STAFF RECOMMENDATION
0 Murphy Road (Acklen Park Drive)
October 18, 2017

Application: New construction – infill (six single-family lots)
District: Richland-West End Addition Neighborhood Conservation Zoning Overlay
Council District: 24
Map and Parcel Number: 10405006500
Applicant: Patrick Chisholm, Vandy Acklen Park LLC
Project Lead: Sean Alexander, sean.alexander@nashville.gov

Description of Project: The applicant seeks approval for revisions to designs for six houses, which were approved by the MHZC in 2016.

Acklen Park - Shared Driveway Exhibit
Nashville, TN
DA Job #16054

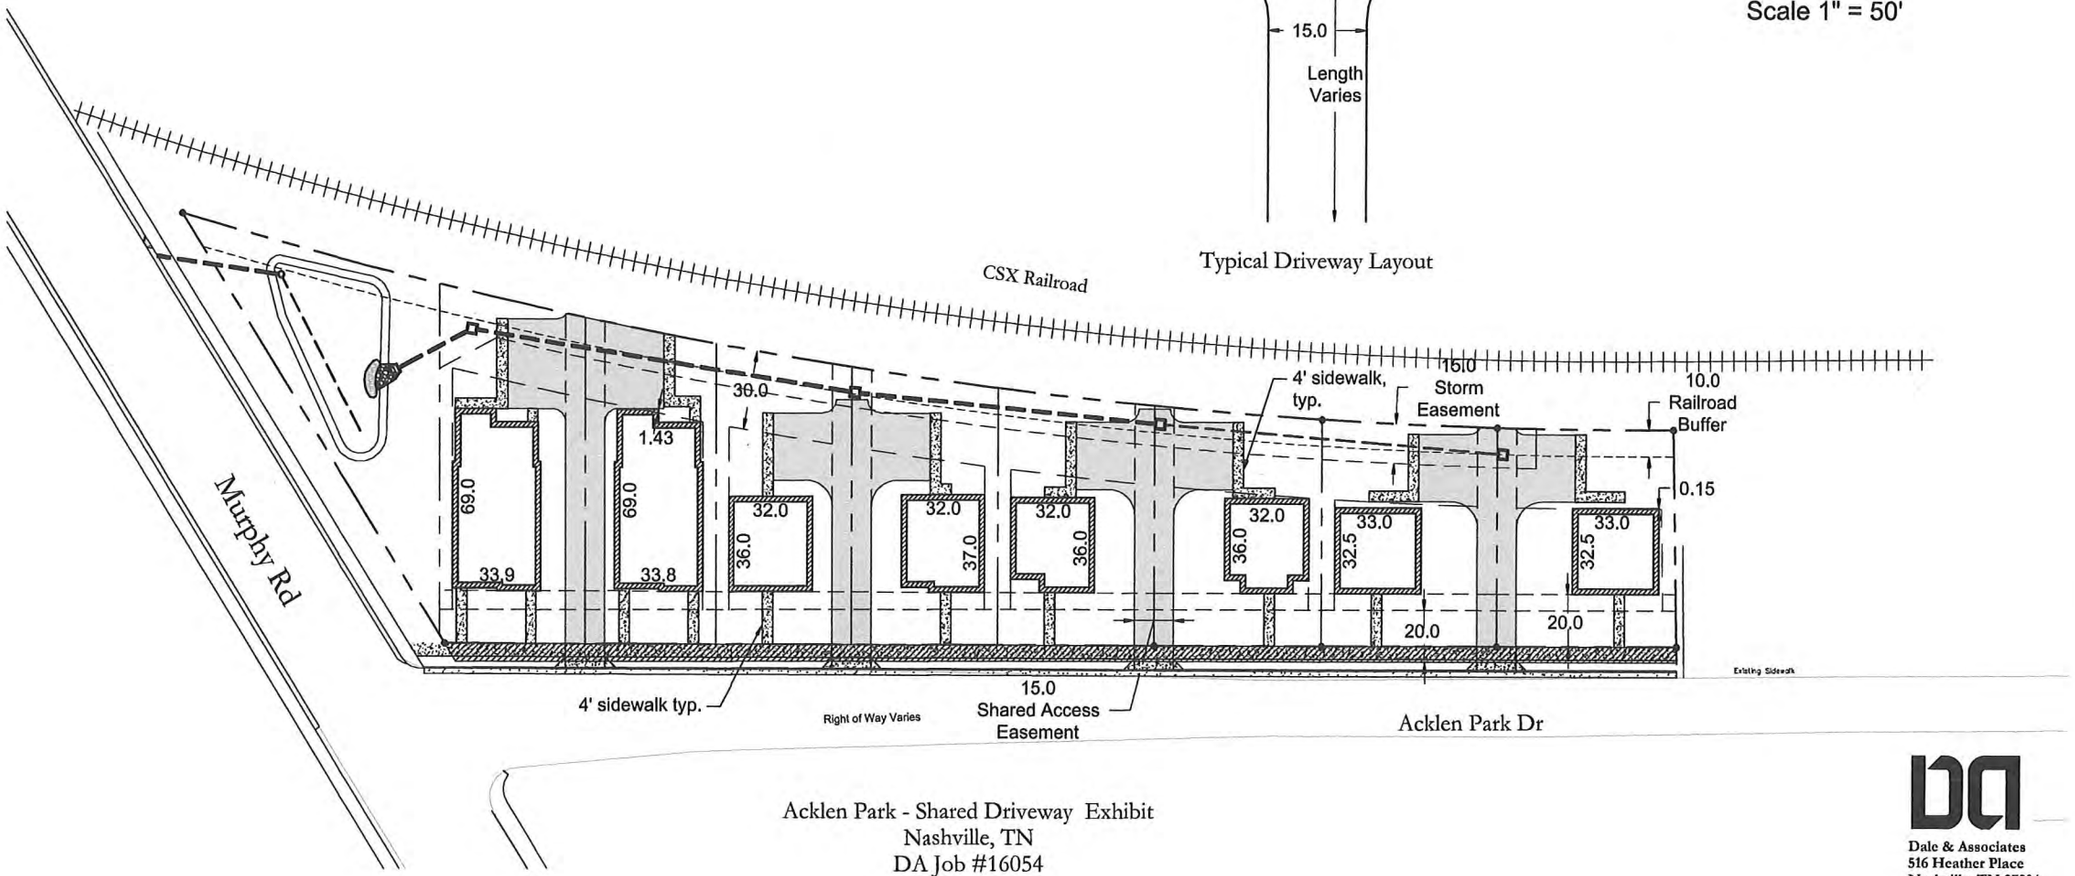
Each building will be shifted to one side of its lot to allow shared driveways between lots 1 and 2, between lots 3 and 4, and between lots 5 and 6. The side setbacks will be five feet (5') on the narrow side, varying from fourteen feet (14') to nineteen feet (19') on the wider side depending on lot width. These setbacks are consistent with the surrounding context, with historic houses also shifted to one side with a driveway on the other. The fronts of the buildings aligned with the adjacent house at 522 Acklen Park Drive, Staff finds that the proposed setbacks and rhythm of spacing will be compatible with the surrounding context and will meet section II.B.1.c of the design guidelines.
